Request by Exclusively Roses, Inc. for site plan approval to construct a new building at 421 Glacier Moraine Drive.

Approving a site plan to construct a new commercial building at 421 Glacier Moraine Drive, Stoughton, WI.

I have completed a review of the proposed building site plan for Exclusively Roses, 421 Glacier Moraine Drive, Stoughton, WI. 53589 – plan received 11/5/19. As noted, additional information may be required to be provided or shown on the plan.

C 101

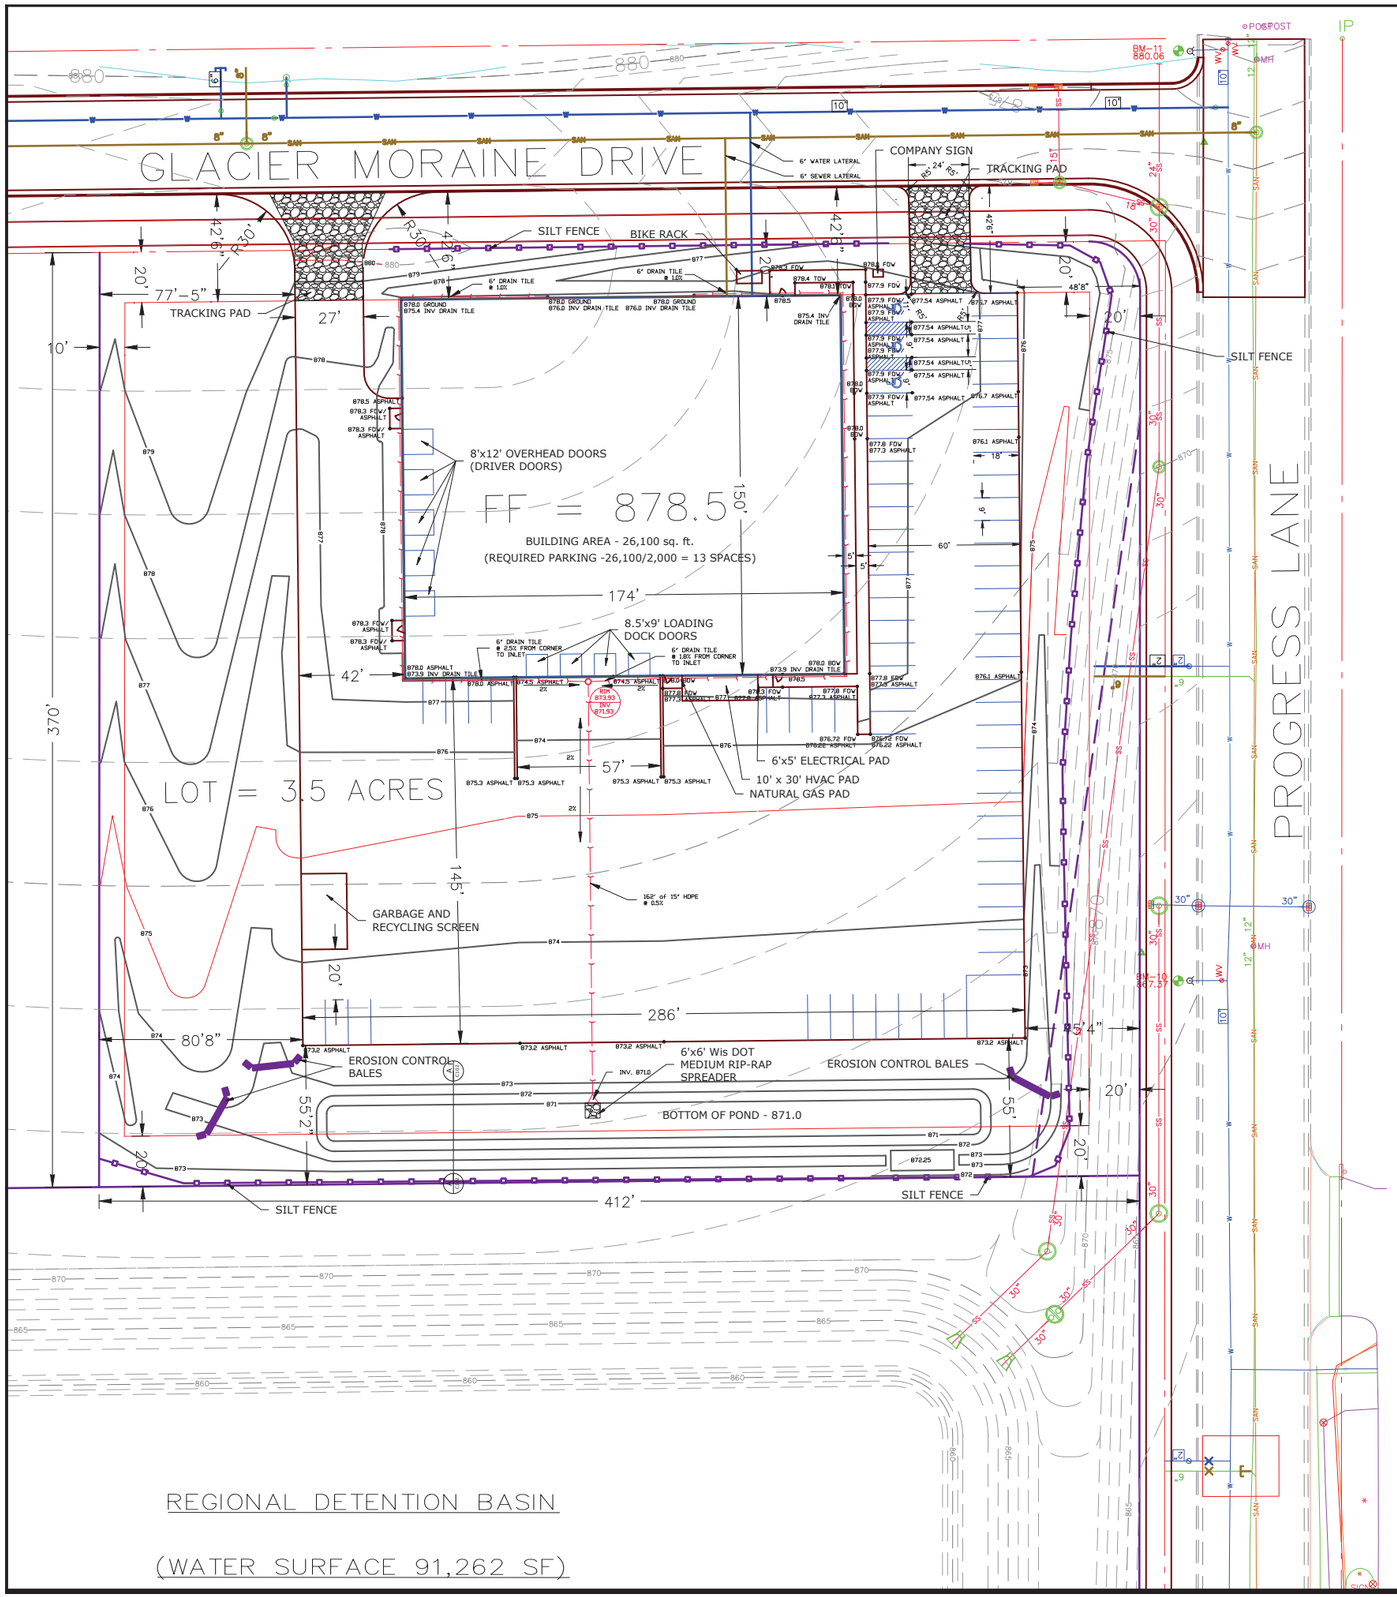
5. The parking aisle width for 90 degree parking shall be a minimum of 24 feet. **The plan meets this requirement.**

7. Except for handicap parking stalls, the minimum parking stall length shall be 18 feet with a minimum width of 9 feet. **The plan meets this requirement.**

8. Per section 78-704 (13) (a), bicycle parking is required equal to 10% of the automobile parking space requirement. **Six bike spaces are required. The bike rack is shown on the plan.**

12. The minimum paved surface setback from a side lot line is 5 feet while the minimum is 10 feet from a right-of-way line. **The plan meets these requirements.**

21. All exterior trash storage areas shall be located within a gated enclosure which completely screens the view a said trash. The exterior of said enclosure shall be constructed of some or all of the materials used on the main building. **The plan meets this requirement.**

ELEVATIONS

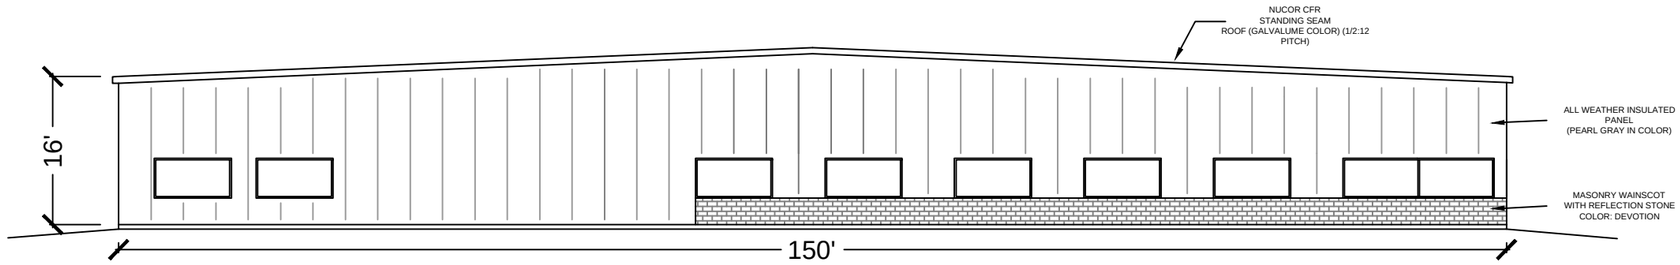
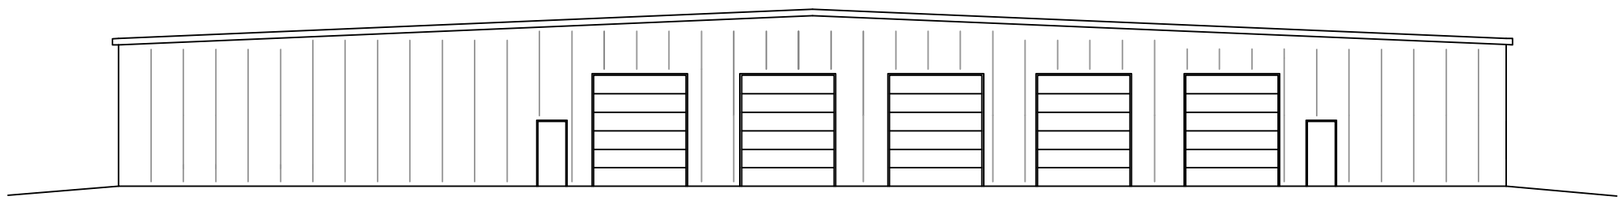
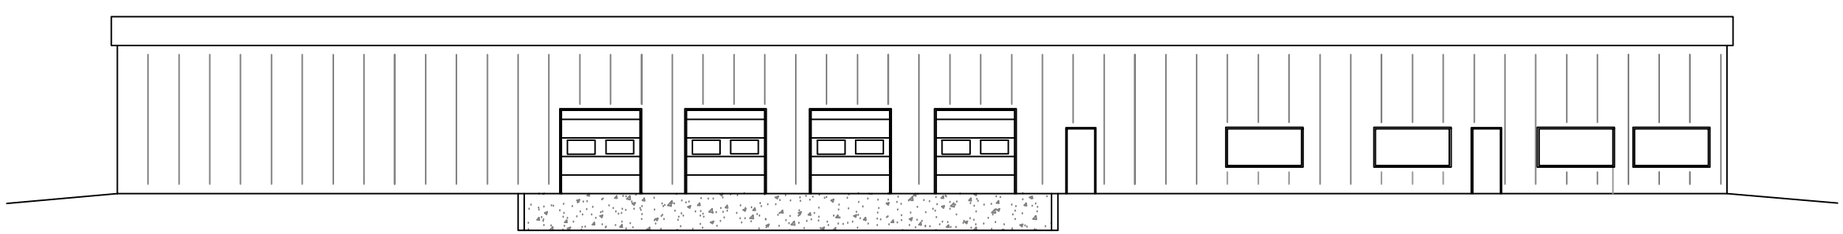
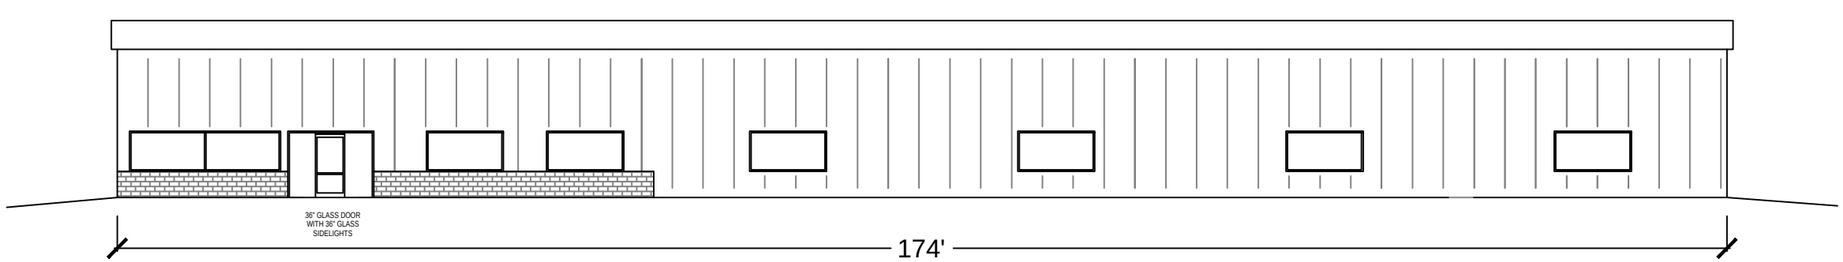
16. The maximum building height requirement is 40 feet. **The plan meets this requirement.**

24. Architectural and design elements shall be compatible with the surrounding area and community standards and shall minimize user-specific design elements as determined appropriate by the Planning Commission. **Architectural design is part of the site plan review process as determined by the Plan Commission. Color charts have been provided.**

Exclusicvely Roses
Stoughton Business Park
121 Flagship Drive Stoughton

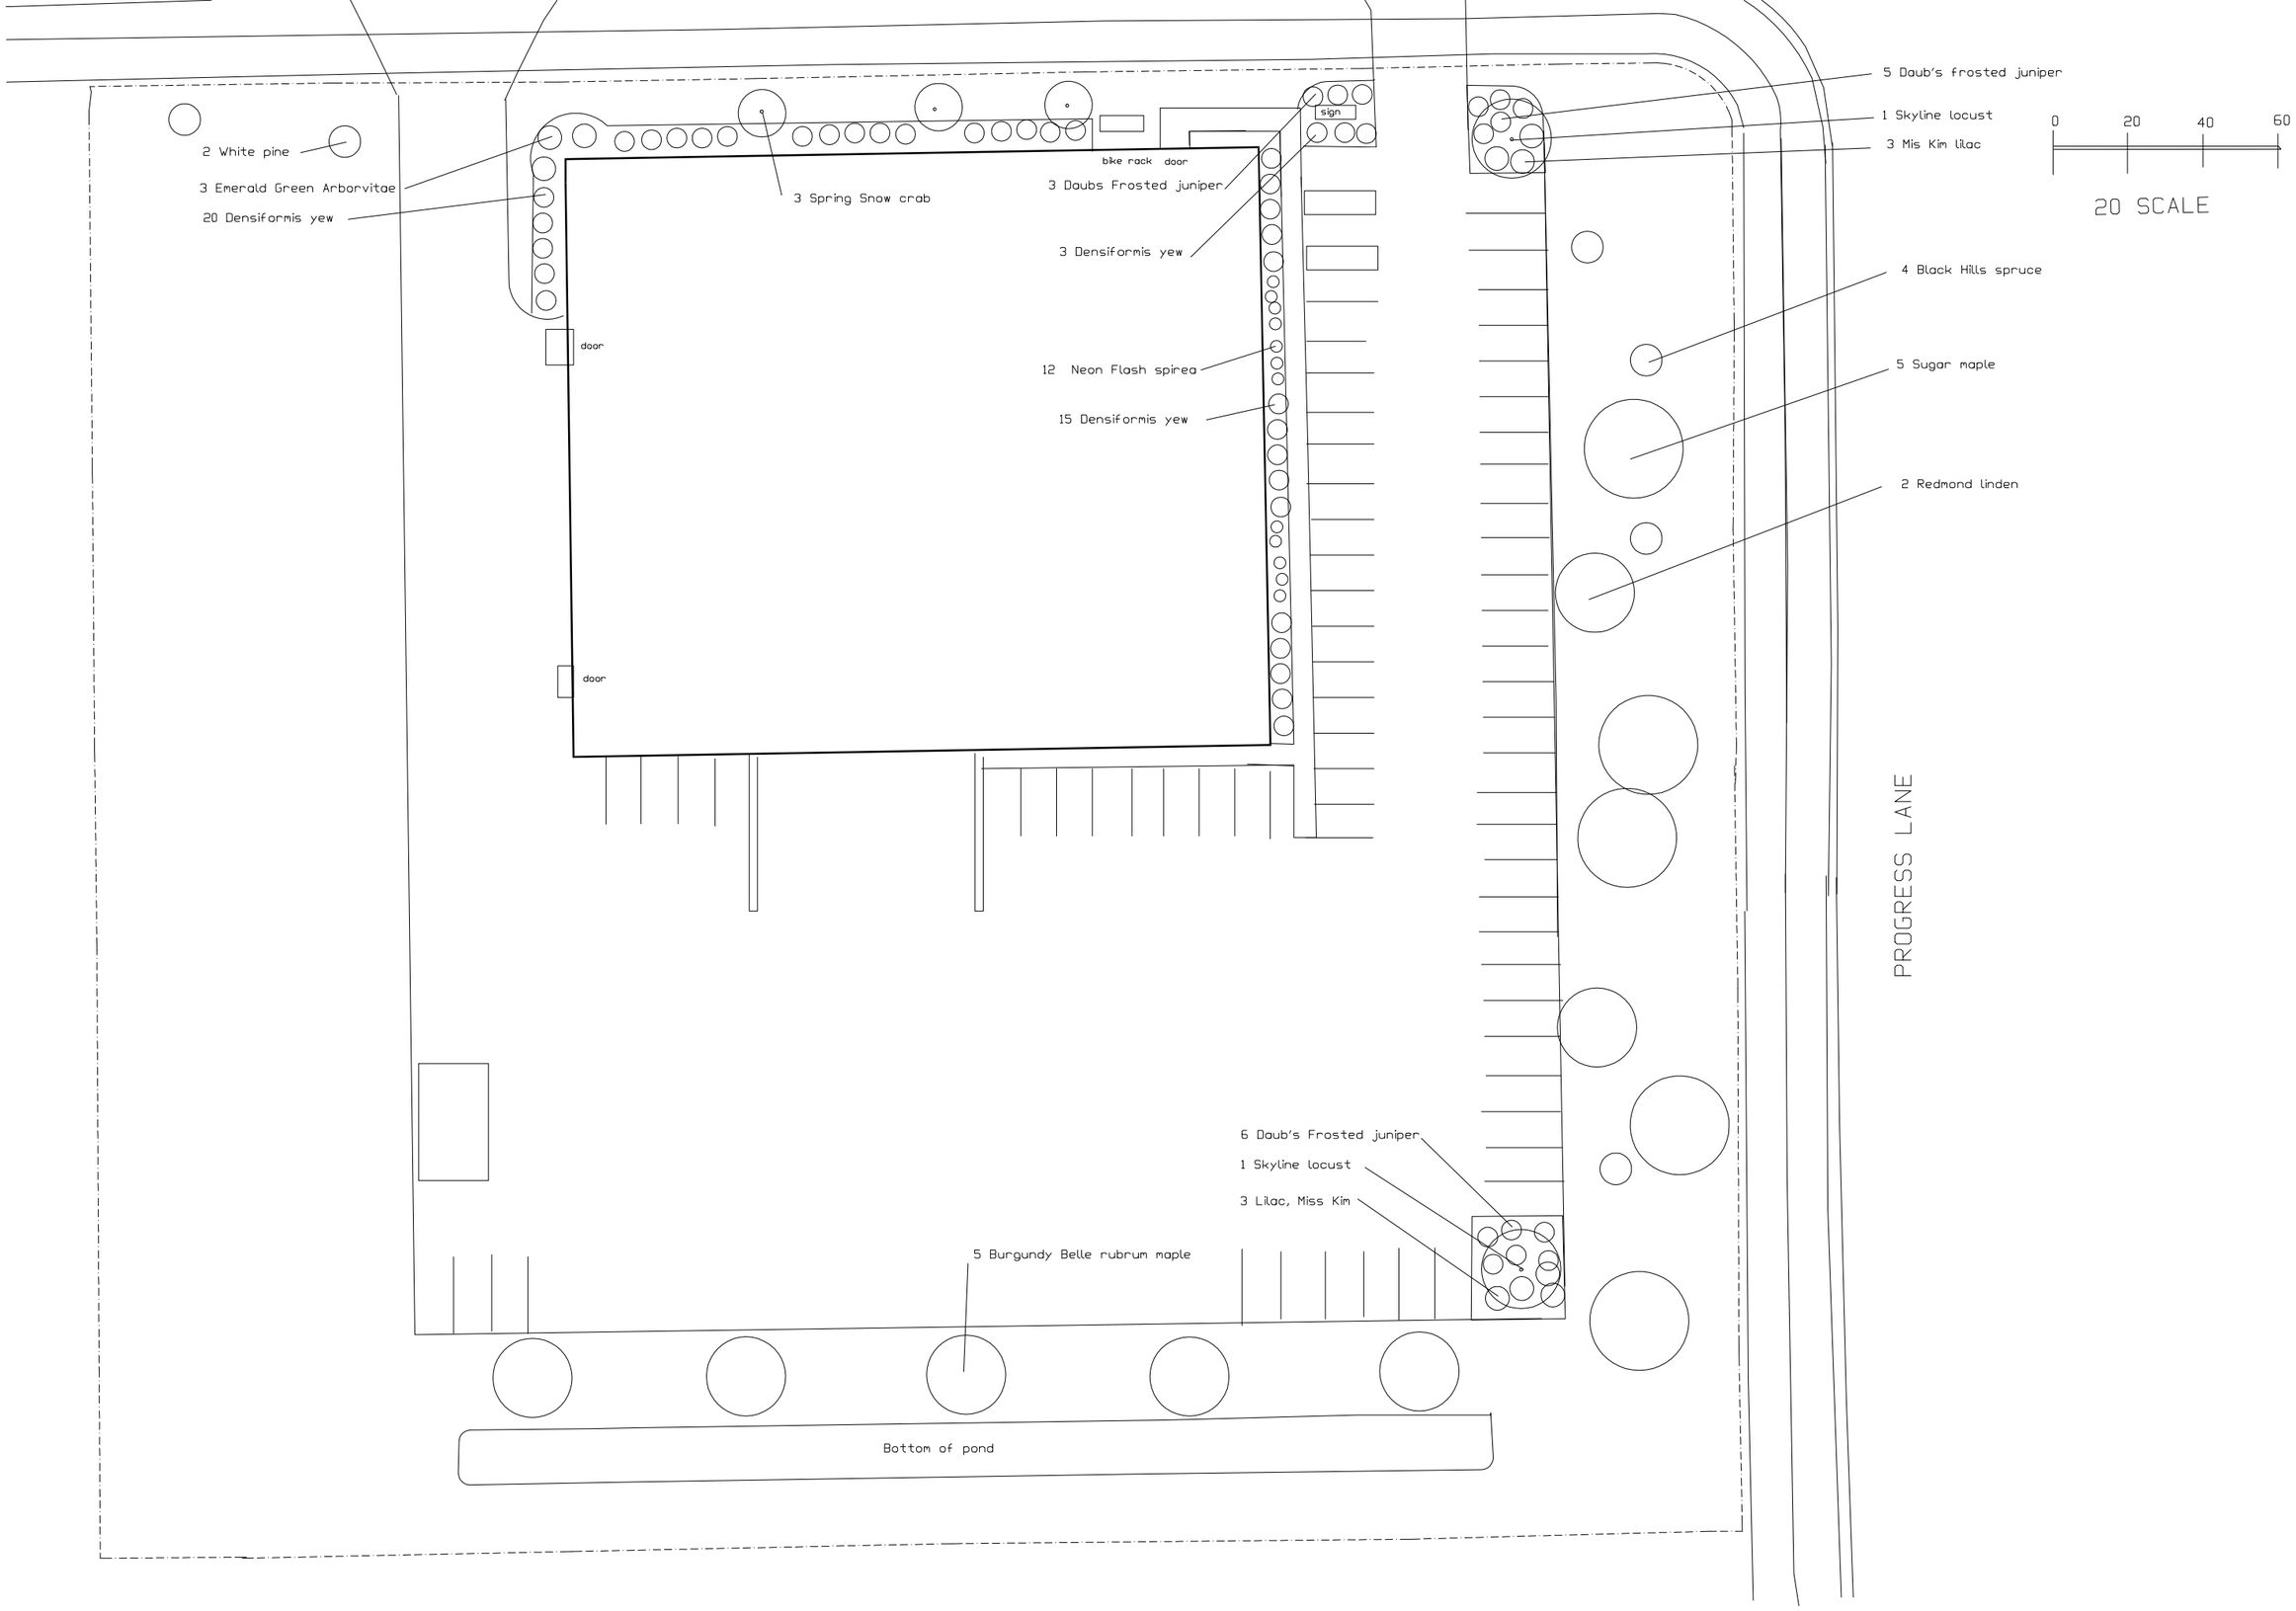
18. A landscaping plan which meets the requirements of Article VI of the zoning code will need to be provided. **The plan meets these requirements.**
